WHEELS, TIRES AND FINAL DRIVE

FRONT WHEEL HUB AND MOUNTING BOLTS

Fig. 20-25 ① Front wheel hub
② Disc plate mounting bolts

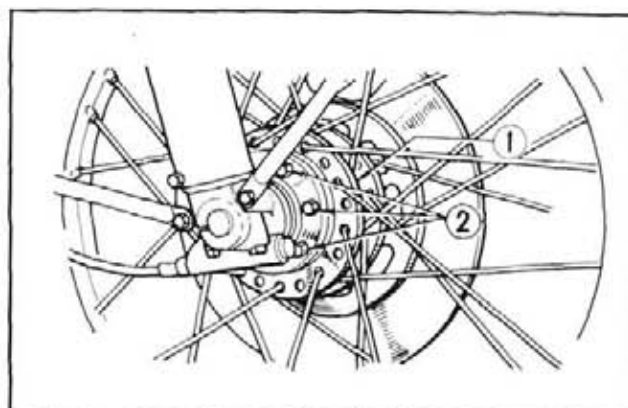
As the width of the front wheel hub was made 0.157 in. (4 mm) narrow in width, the length of the mounting bolts was changed from 4.17 to 4.02 in. (106 to 102 mm) shortened by 0.157 in. (4 mm).

Whenever replacing these parts, make sure that the proper length bolts are used. Using the old longer bolts on the new hub will cause the disc plate to loosen during riding. When the front hub is replaced, the associated parts corresponding to this hub must be replaced in set. Old and new parts are not interchangeable.

Fig. 20-26 ① R. rear wheel damper
② L. rear wheel damper

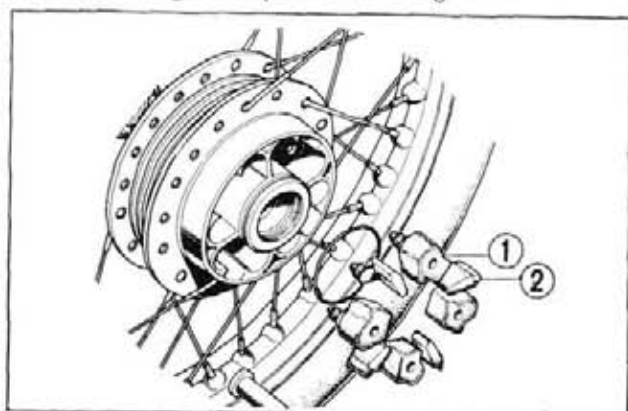
The shape of both side wheel dampers which was changed as shown in figure, absorb the shock when the rear wheel was turned by the drive chain and it makes the the drive chain to prolong the service life.
